H. B. ROBINSON UNIT NO. 2
LICENSE DPR-23
REFUELING OPERATIONS

Upon further review of the containment purge system modification for the H. B. Robinson Unit No. 2 plant, which was outlined in our previous submittal of January 23, 1973 regarding refueling operations, we have decided to eliminate the bypass line around the filter box area. Thus, the exhaust from the containment will always pass through a particulate and iodine filter whenever the containment is being purged. Information pertaining to this change is attached in the form of a revised answer to Question 1 of your December 20, 1972 request for information. Also attached is a revised answer to Questions 5 and 6, which changes and clarifies the proposed Technical Specification change that was requested. This information supersedes that contained in our previous submittal.

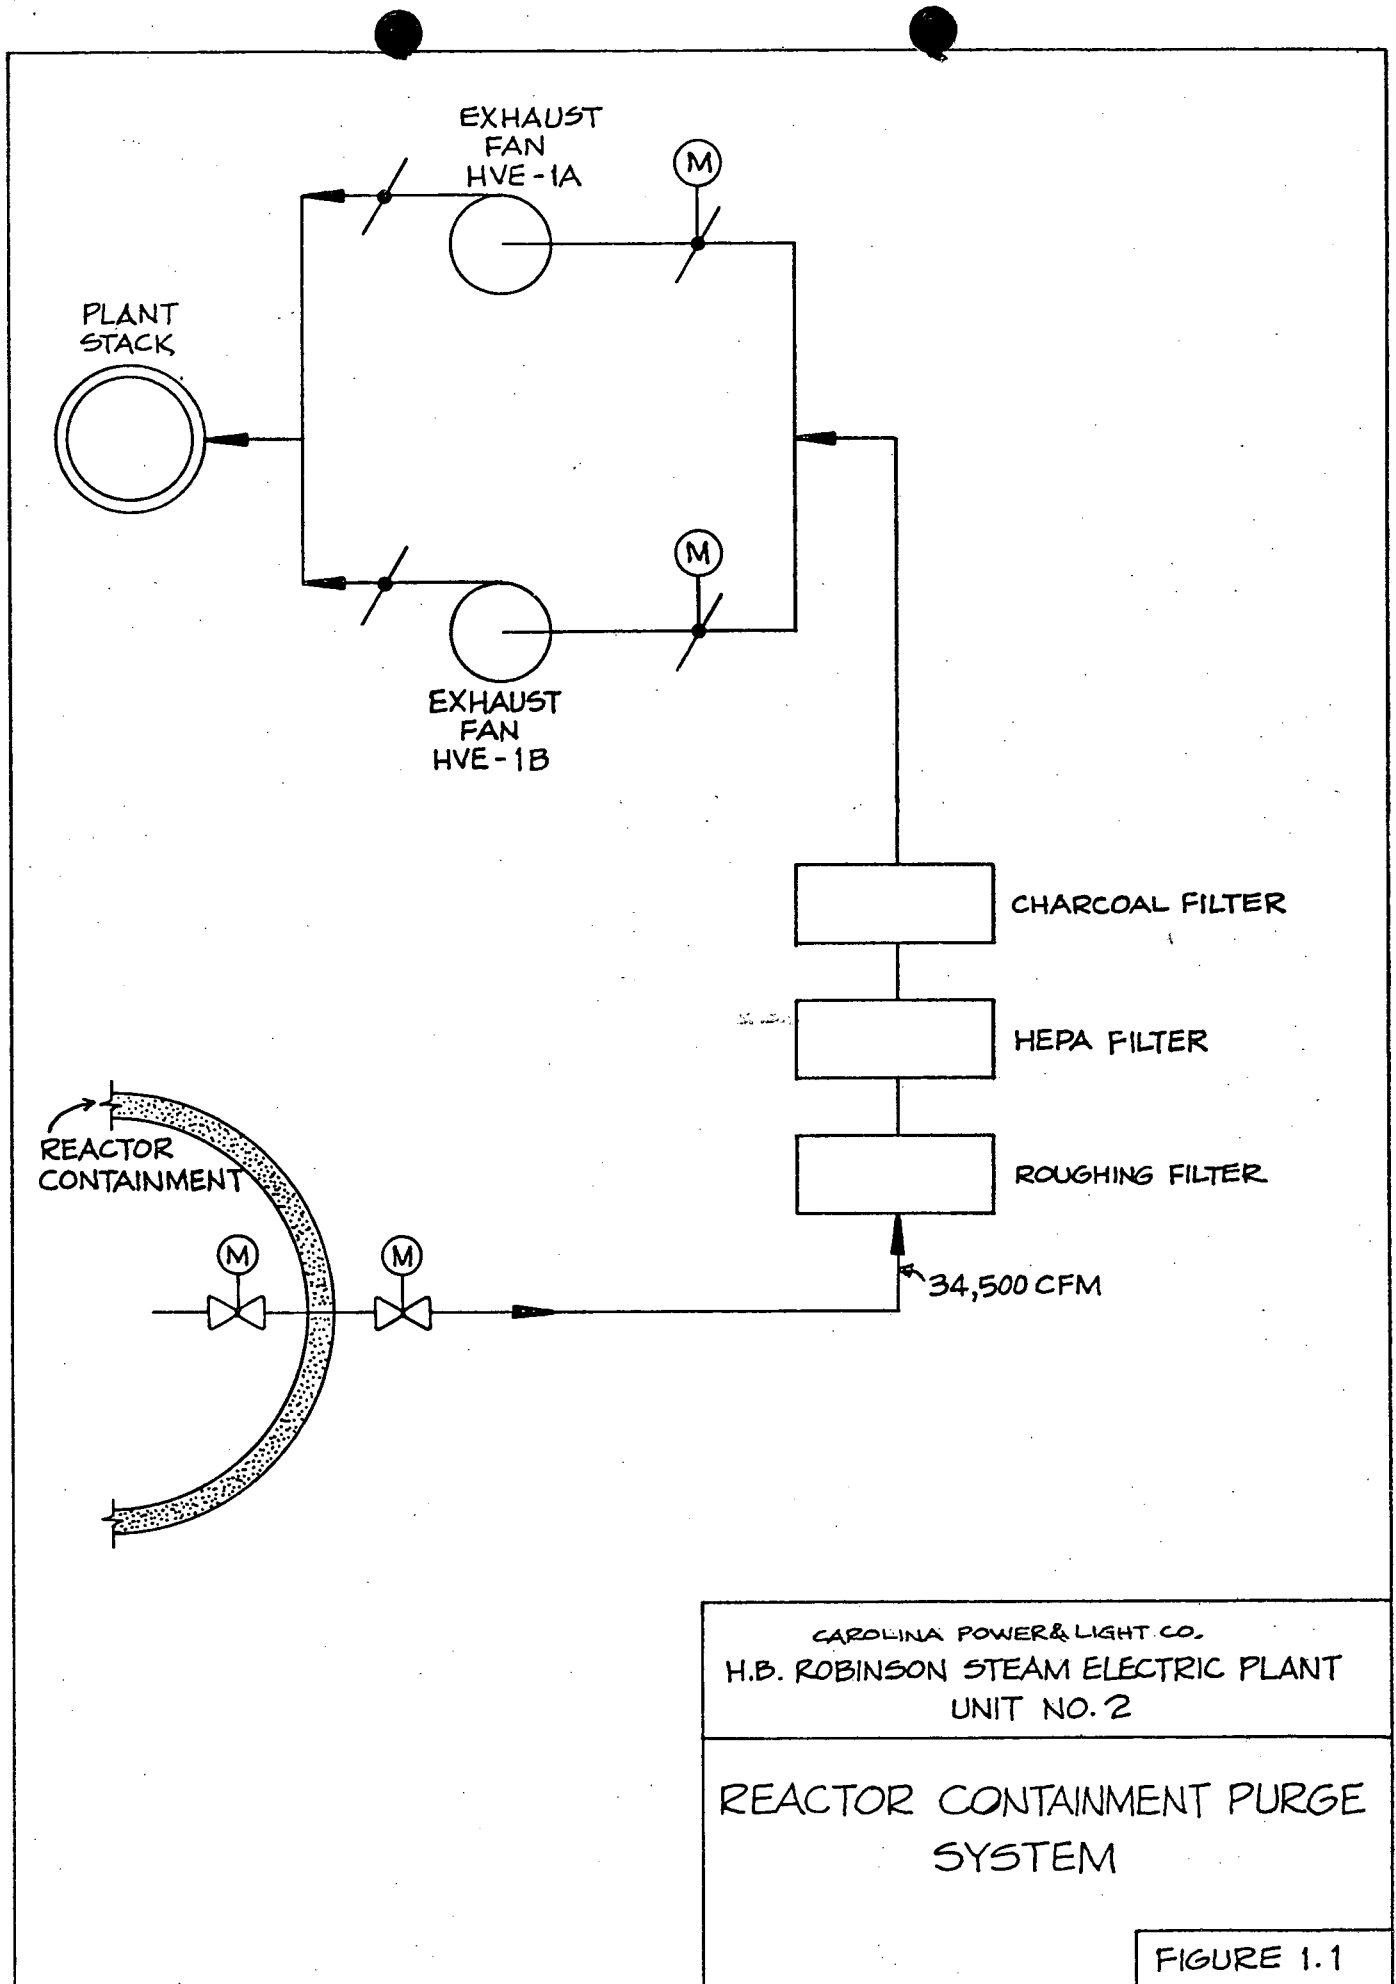
The Robinson safety evaluation of fuel handling accidents appears to assume that activity released into the upper half of the containment vessel:

- a. undergoes perfect mixing with the atmosphere in the upper half of the containment vessel, and
- b. is released to the atmosphere in a quantity determined by one containment exhaust fan operating at a flow rate of 35,000 cfm for five minutes.

The first assumption appears nonconservative because 8000 cfm of the 35,000 cfm exhaust air flow is drawn directly from above the refueling water surface before mixing can occur. The second assumption seems conservative, but it is not clear that the two assumptions taken together yield conservative results. Please justify the conservatism of the results, or, if this is not possible, provide a new evaluation which you show to be conservative.

The postulated fuel handling accident within the containment has been reanalyzed with the following assumptions:

1. All activity released from the pool as a result of the postulated accident is drawn directly from the refueling water surface, into exhaust ducting which connects directly to the containment purge exhaust system.

2. All activity is released to the plant vent before the automatic isolation of the containment purge system occurs.

Use of the above assumptions necessitated the installation of a charcoal filter in the containment purge exhaust ducting. This new arrangement is shown on Figure 1.1. When irradiated fuel assemblies are handled in the containment, all containment purge exhaust passes through the charcoal filter. The charcoal filter is Mine Safety Appliances Company, Type MSA 85851, and has a minimum depth of 2 inches and minimum residence time of 0.25 seconds. The total capacity through the charcoal filter is 34,500 scfm, with a flow velocity through the bed of 40 fpm.

In addition to the above assumptions, the assumptions recommended in Safety Guide 25, as amplified by our responses to questions 2 and 3, were used in evaluating the postulated accident. The resultant 2-hour exposures at the site boundary were:

Thyroid:	29.3 rem
Whole Body:	3.17 rem
